MIDHURST LANDOWNERS GROUP INC.

Re: Follow-up to July 2, 2025 Council Meeting

MLG Response to Ainley Group High-Level Peer Review (July 2, 2025) –
Water & Wastewater Servicing of Expanded Midhurst Secondary Plan
Materials Submitted by Midhurst Landowners Group

Re: **Bayfield Street Corridor Servicing**
Midhurst Secondary Plan, Township of Springwater

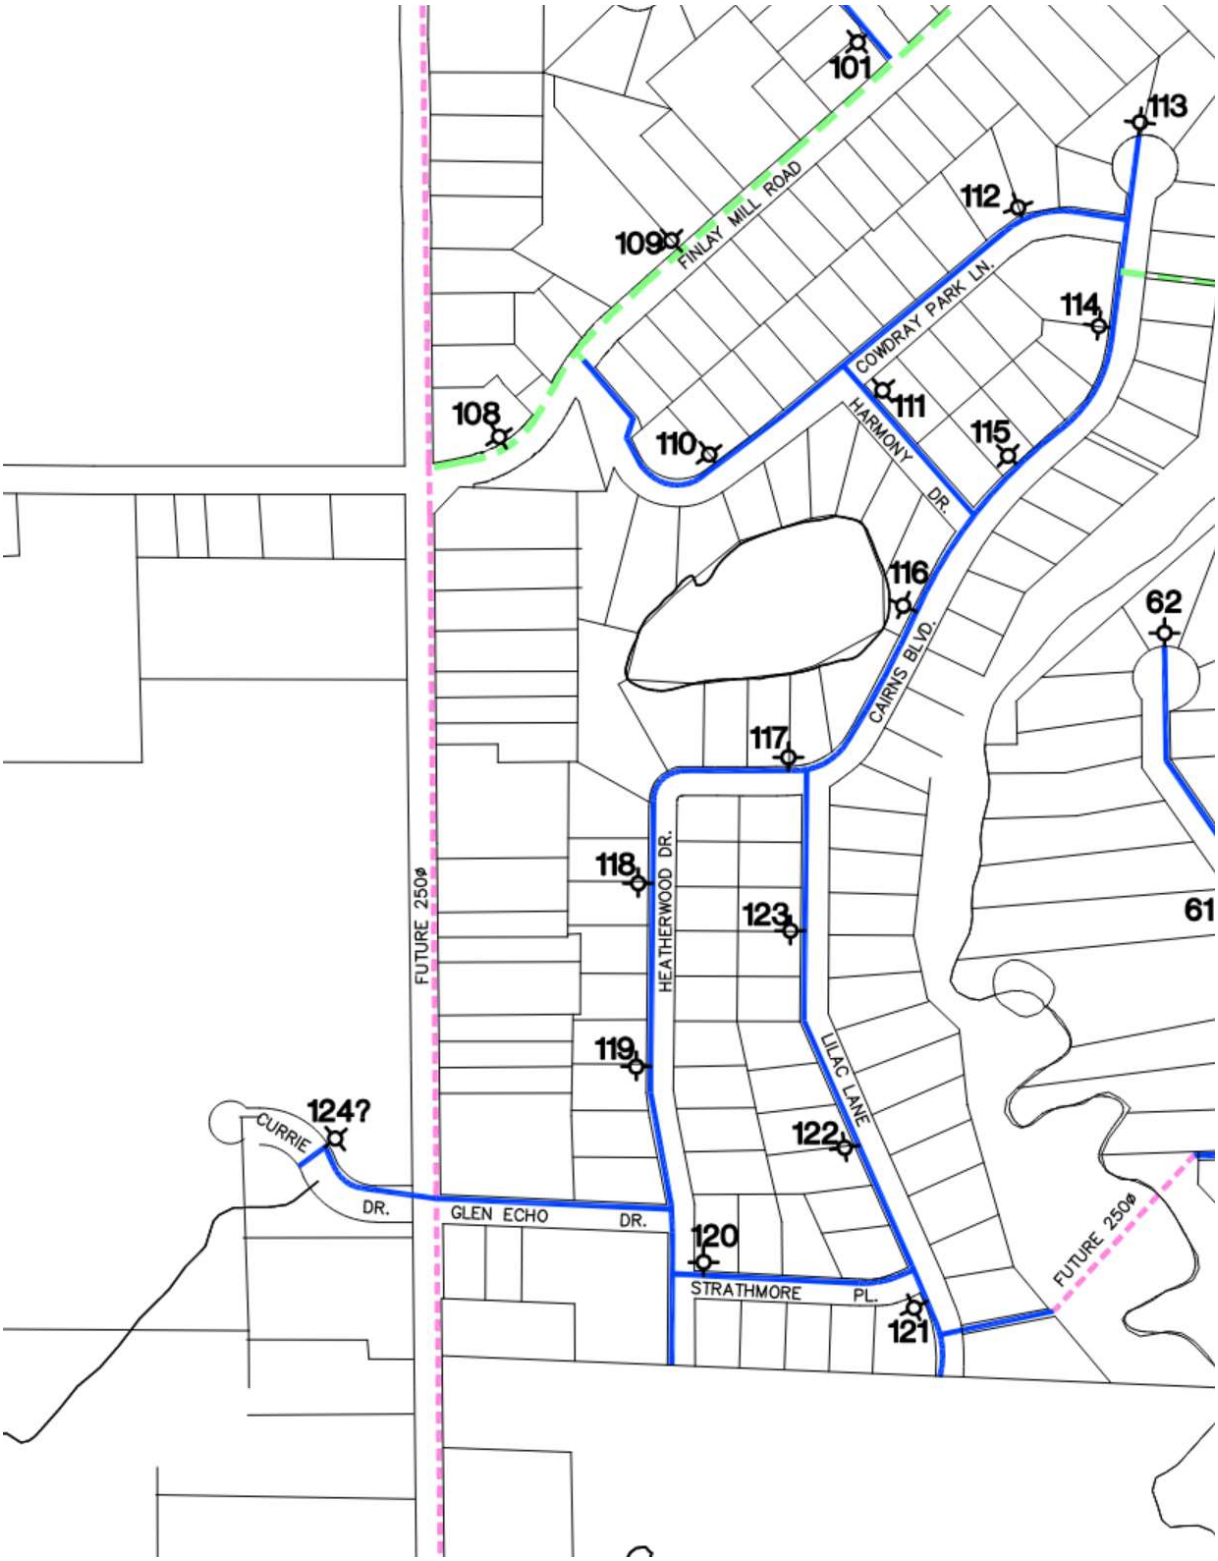
This memo is being provided in response to a comment made at the July 2, 2025 Council Meeting, to clarify and confirm that provisions for servicing the Bayfield Street Corridor were included in the Municipal Class EA.

We have included a map prepared by the Township's Engineers, Ainley Group that was included within the Environmental Study Report (ESR) for the Class EA, which identifies a future watermain on Bayfield as part of the existing water distribution system to service the Bayfield Street Corridor. A snapshot of this map is included on the following page for ease of reference.

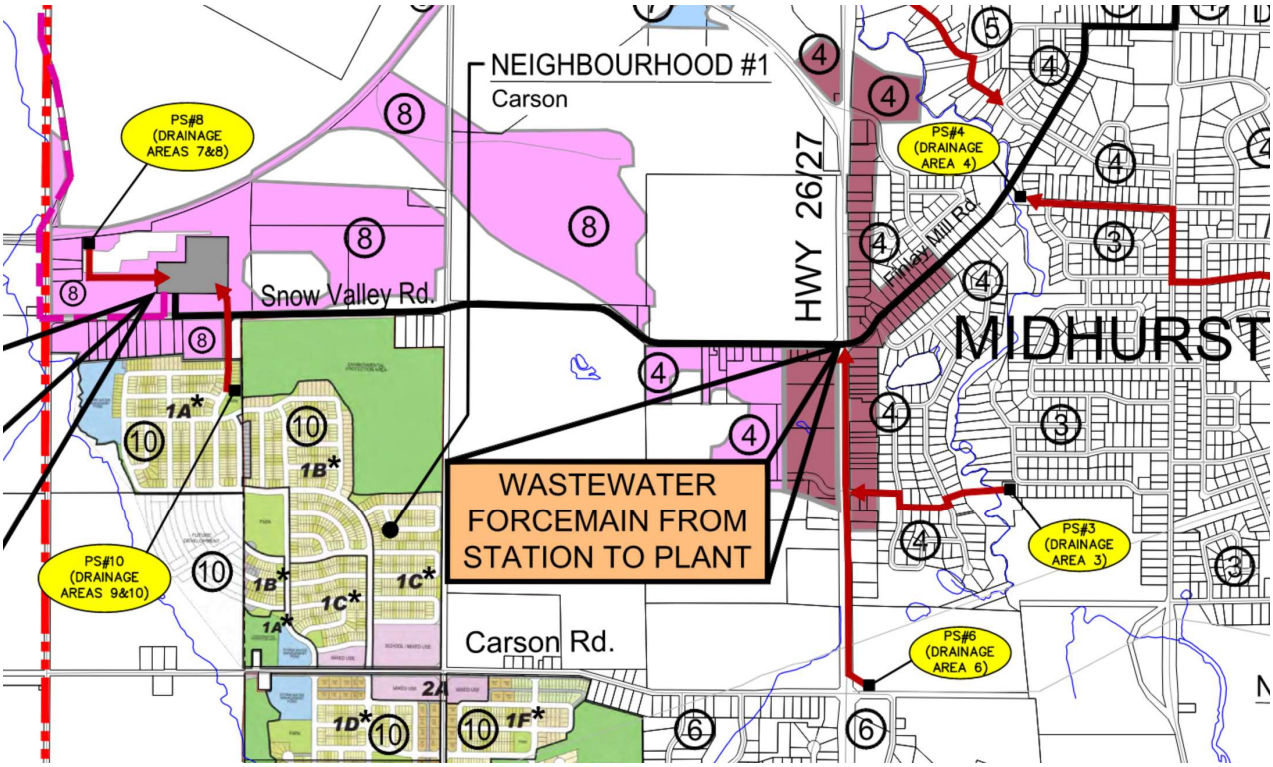
The Class EA – Phase 3 & 4 notes in Section **6.6 Collection Options, 6.6.3 Sewage Pumping Stations** that it is anticipated that 10 sewage pumping stations will be required to service existing and proposed development in the Secondary Plan area. These stations and their tributary areas were included on Drawing 113027-OP6 (Appendix U of the EA). A snapshot of this figure is included below for reference.

As demonstrated above, the Bayfield Corridor, shown in maroon, was tributary to future sanitary pump station #4 and therefore accounted for in the EA.
